PLANS OF PROPOSED MIDWAY DRIVE PICARDY AVENUE TO CONSTANTIN BLVD CITY PARISH PROJECT No. 20-CP-HC-0008

**SUMMARY OF ESTIMATED QUANTITIES**

**CHANGE ORDER AND/OR SPECIAL AGREEMENT**

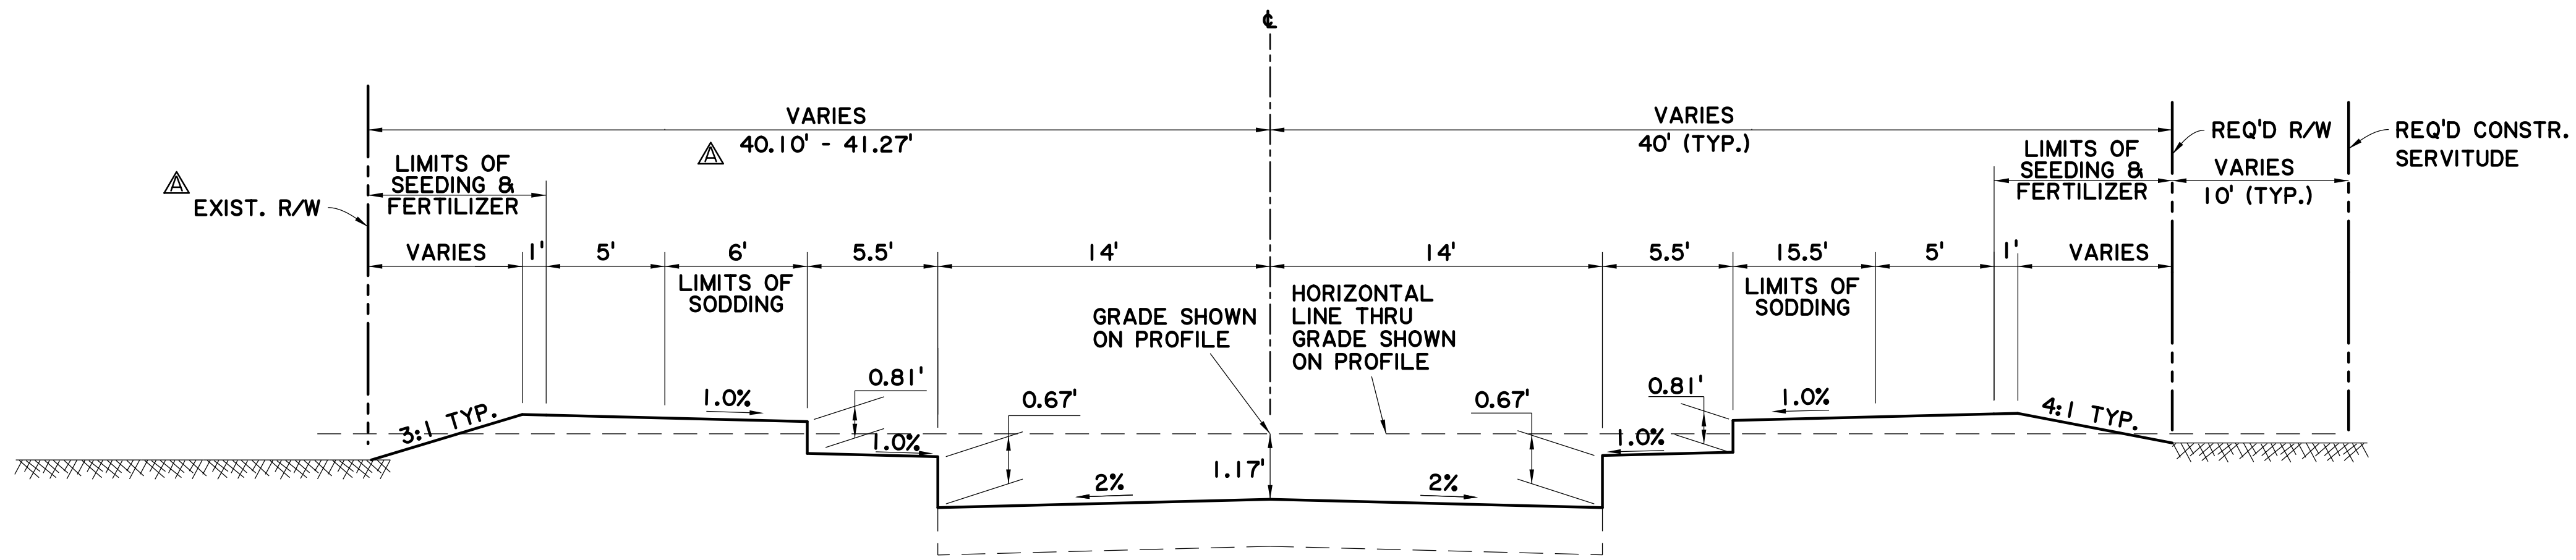
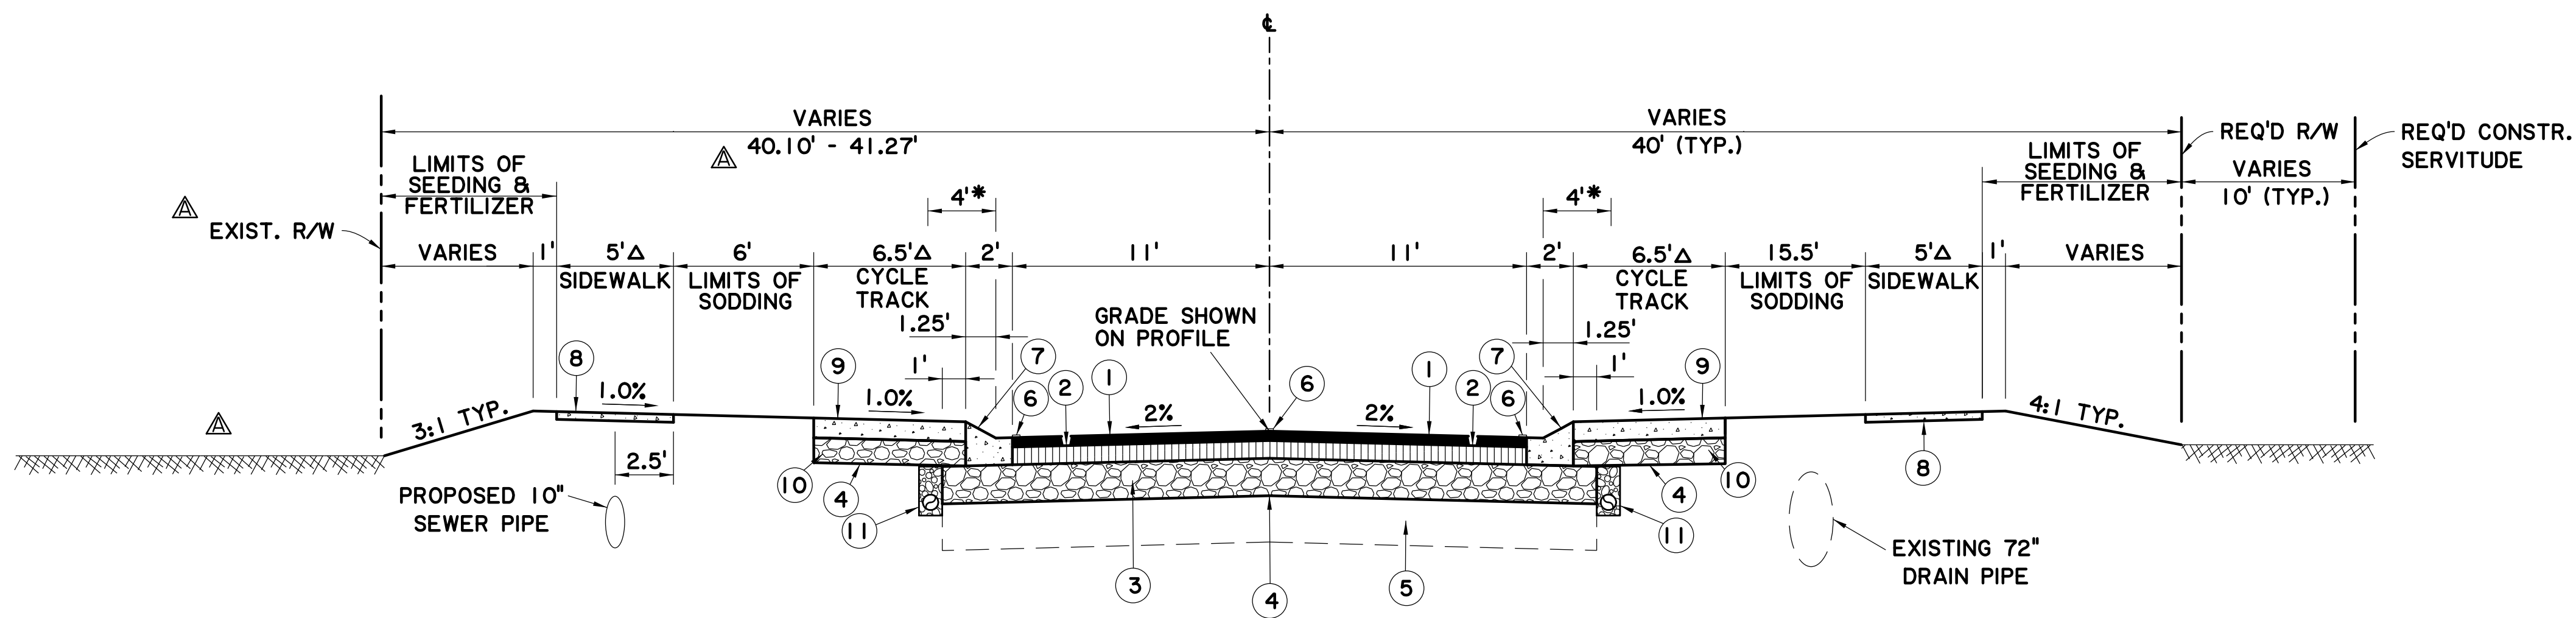
- \* REQ'D LATERAL OFFSET
- Δ PERVIOUS PAVEMENT ENDS AT STA. 625+92.  
CYCLE TRACK TO BE 6" CONCRETE WALK FROM 625+92 TO 626+44.95  
SIDEWALK TO BE 4" CONCRETE WALK FROM 625+92 TO 626+44.95  
SEE PLAN SHEET FOR ADDITIONAL INFORMATION.

SHEET NUMBER 3aA	
EAST BATON ROUGE PARISH	PARISH
20-CP-HC-0008	CITY PROJECT
1	STATE PROJECT
DESIGNED MFB	DATE
CHECKED GDH	SHEET
DTA	2 OF 6
CHECKED MFB	
REMOVED DRAIN. SERV.; CHANGED DIM. R/W TO CL; R/W;	REVISION DESCRIPTION
5-17-22	DATE
REMOVED DITCH DETAIL	BY
	NO.
TYPICAL SECTIONS & DETAILS	
MIDWAY DR. (PICARDY AVE. TO CONSTANTIN BLVD.)

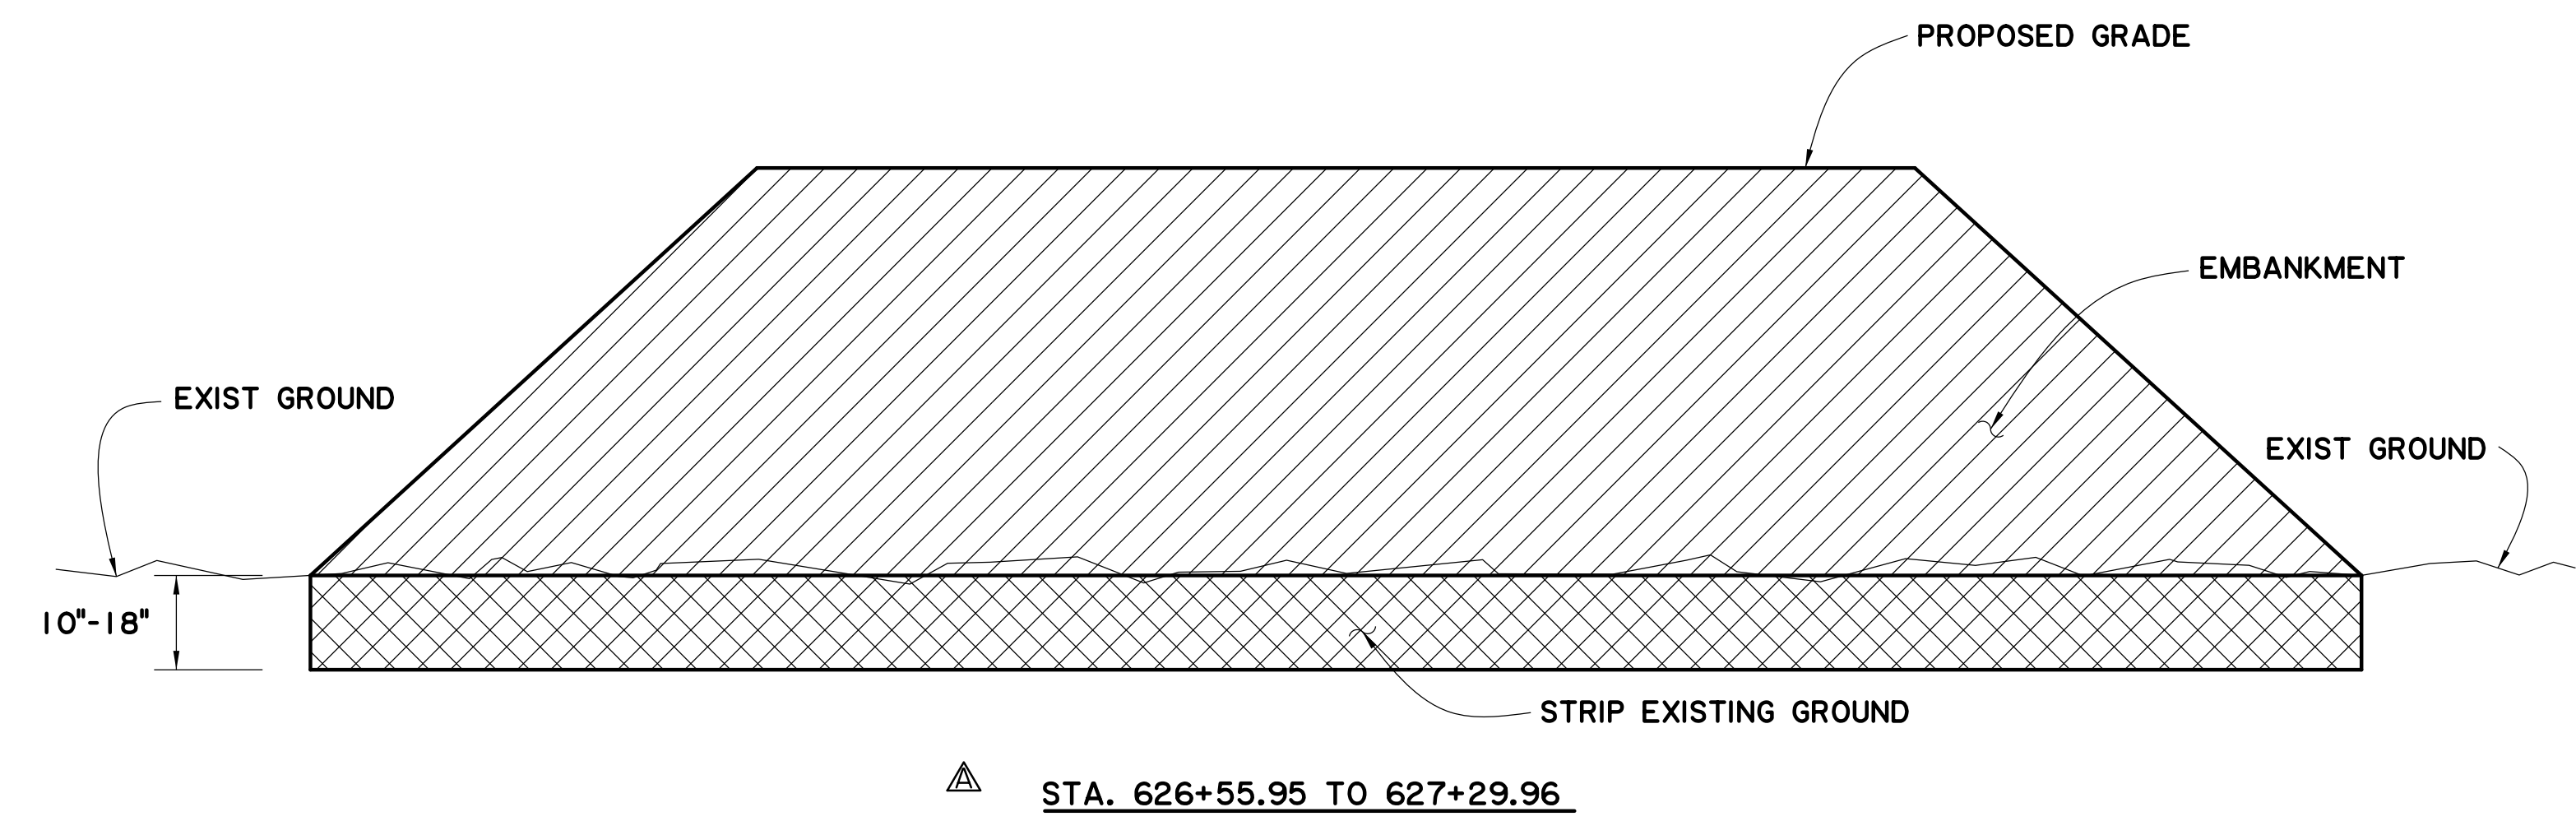
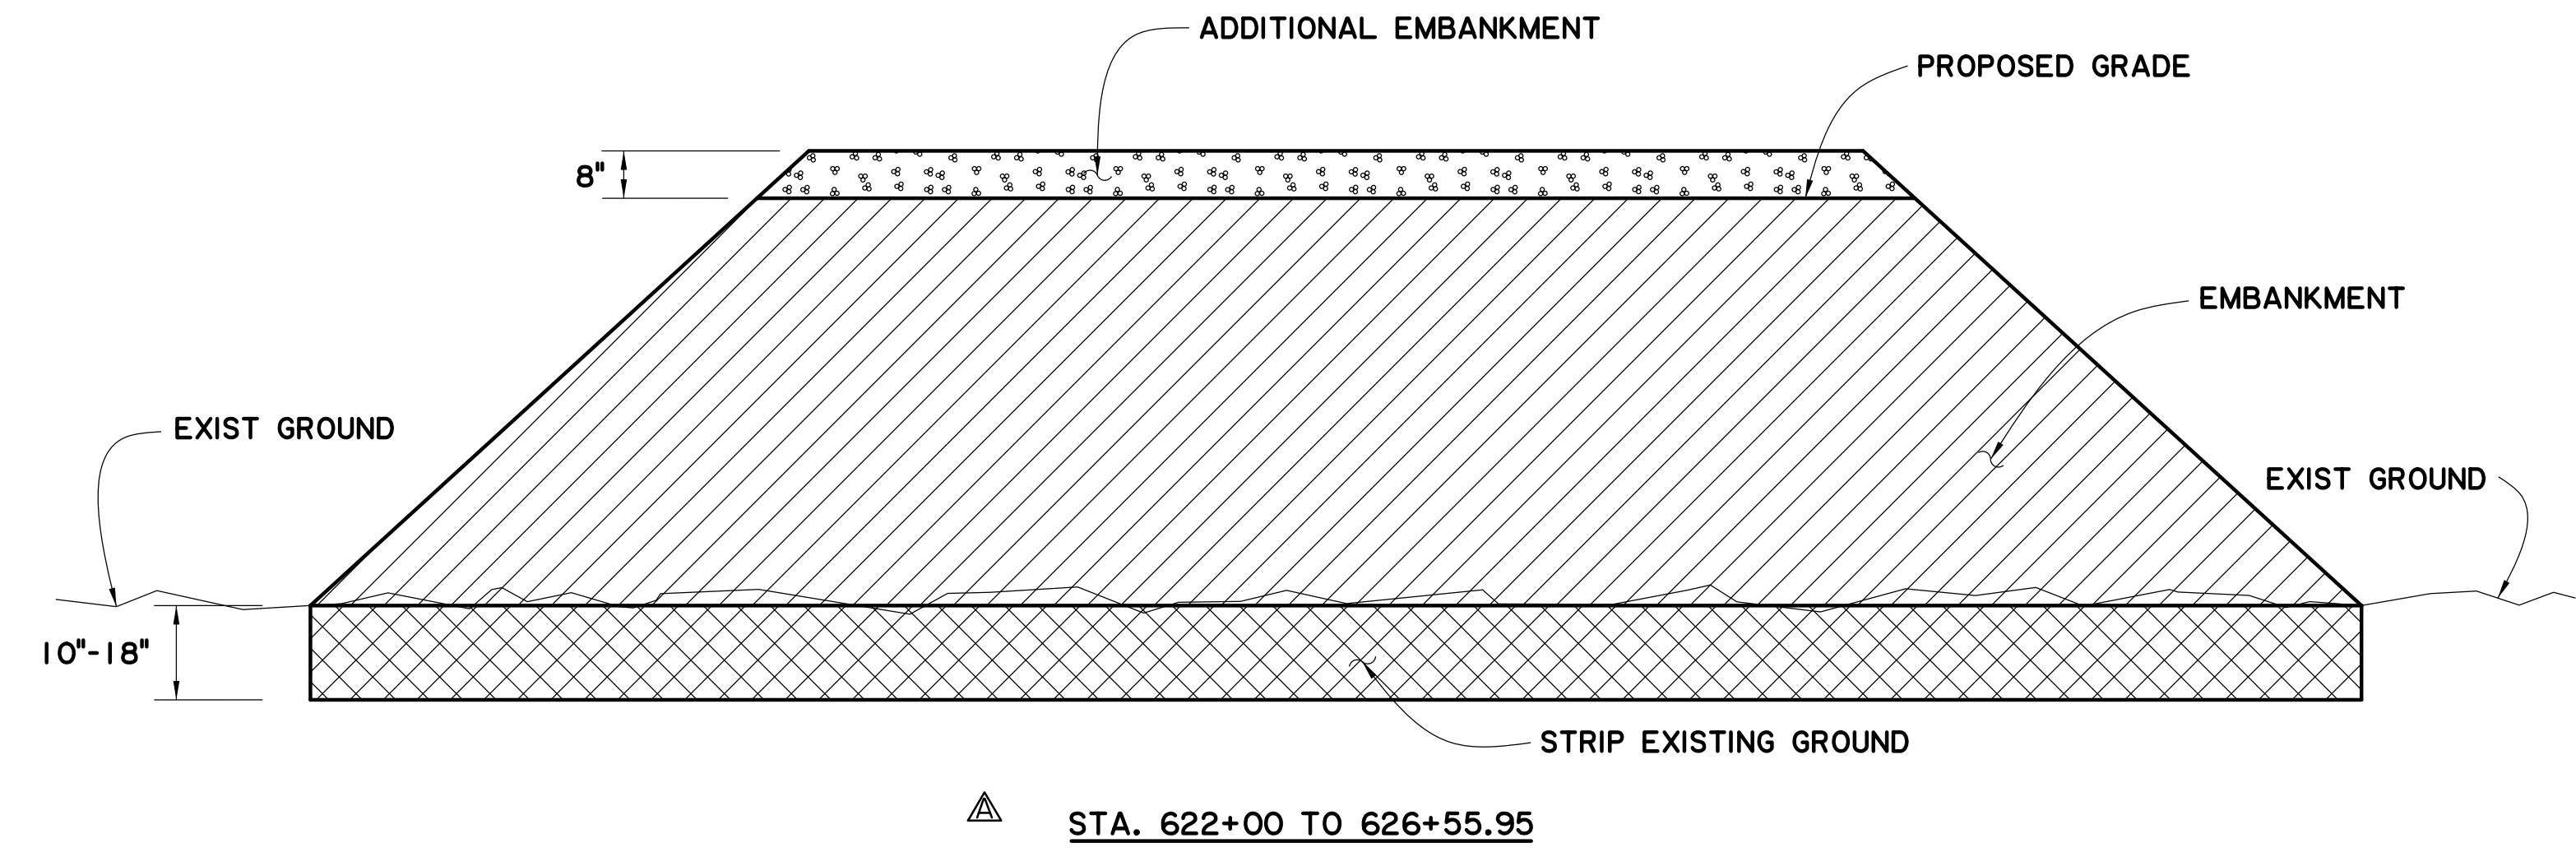
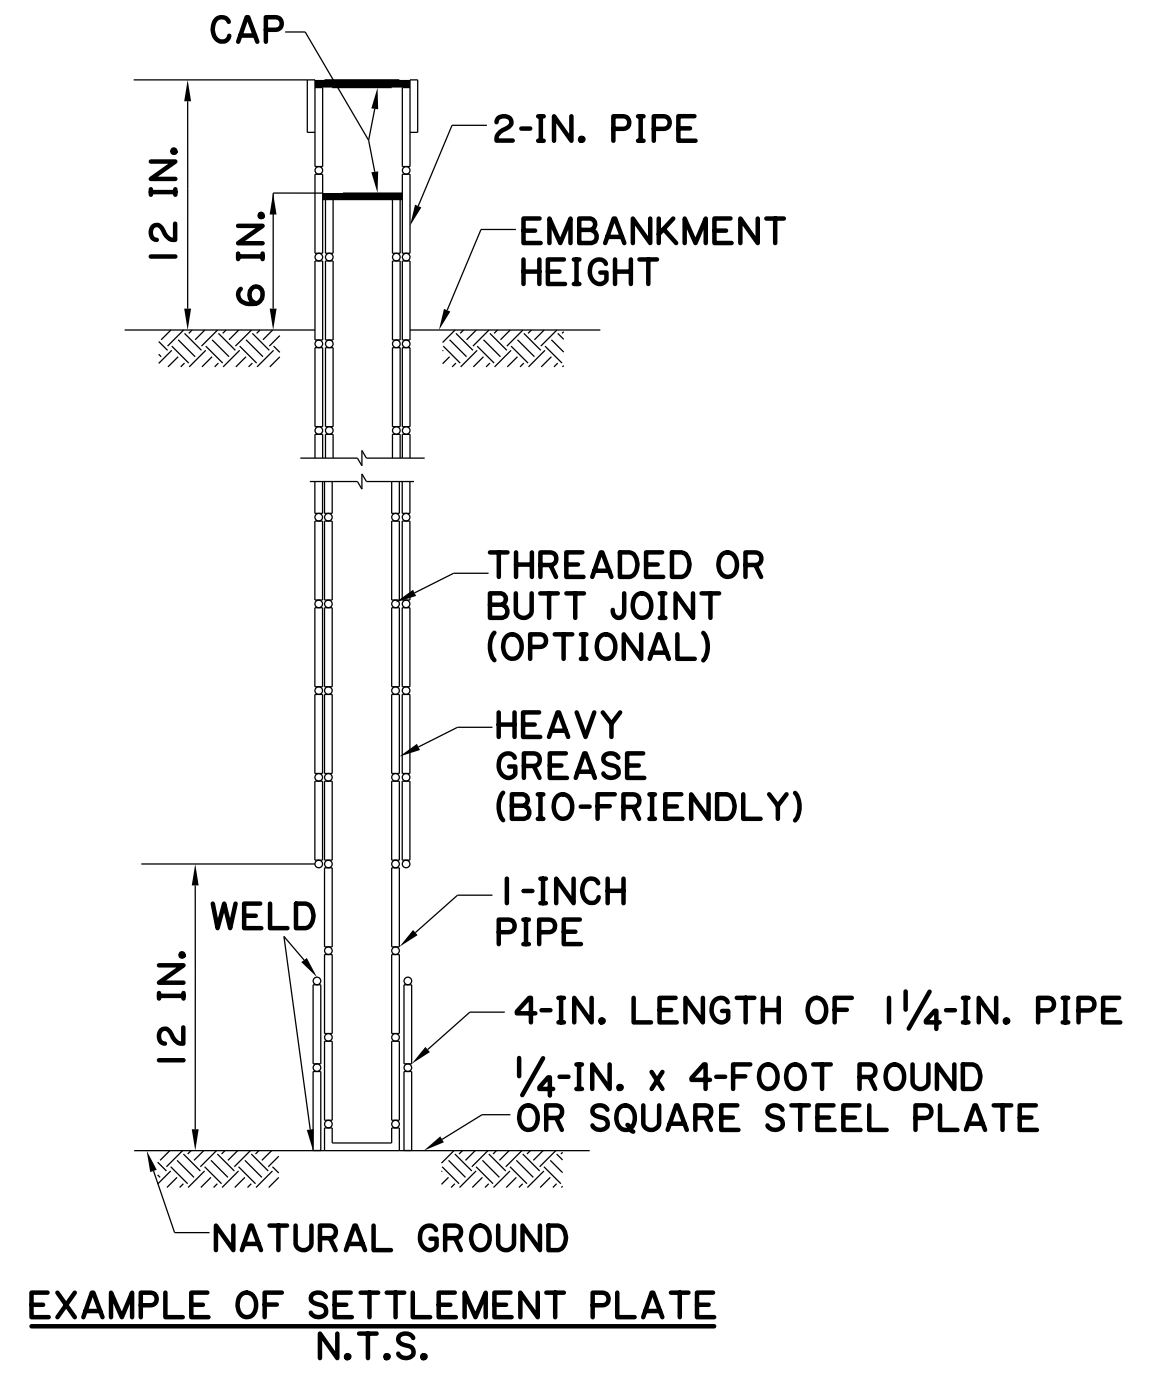
SHEET NUMBER	3eA	PARISH	EAST BATON ROUGE PARISH	PROJECT	20-CP-HC-0008
DESIGNED	MFB	CHECKED	IGDH	DATE	6 OF 6
DETAILED	DTA	CHECKED	MFB	DATE	6 OF 6
CHANGED STATION RANGE; ADDED DETAIL; ADDED SETTLEMENT PLATE AND REVISED STATIONS		BY			
NO.	5-17-22	REVISION DESCRIPTION			
TYPICAL SECTIONS & DETAILS					
MIDWAY DR. (PICARDY AVE. TO CONSTANTIN BLVD.)					
CITY OF BATON ROUGE

**STAGE 1**  
STRIP EXISTING GROUND 10"-18" (STATION 622+00 TO 627+29.96)

**STAGE 4**  
SETTLEMENT OF EMBANKMENT IS EXPECTED TO BE BETWEEN 6"-8". THIS IS EXPECTED TO OCCUR OVER A PERIOD OF APPROXIMATELY 30-60 DAYS. GRAVITY SEWER, AND DRAINAGE STRUCTURES WILL BE CONSTRUCTED AFTER THE EMBANKMENT HAS SETTLED.

SETTLEMENT PLATES	
STATION	NUMBER OF PLATES
MIDWAY DR.	
622+40	1
624+90	1
625+46	1
627+29	1
TOTAL	4
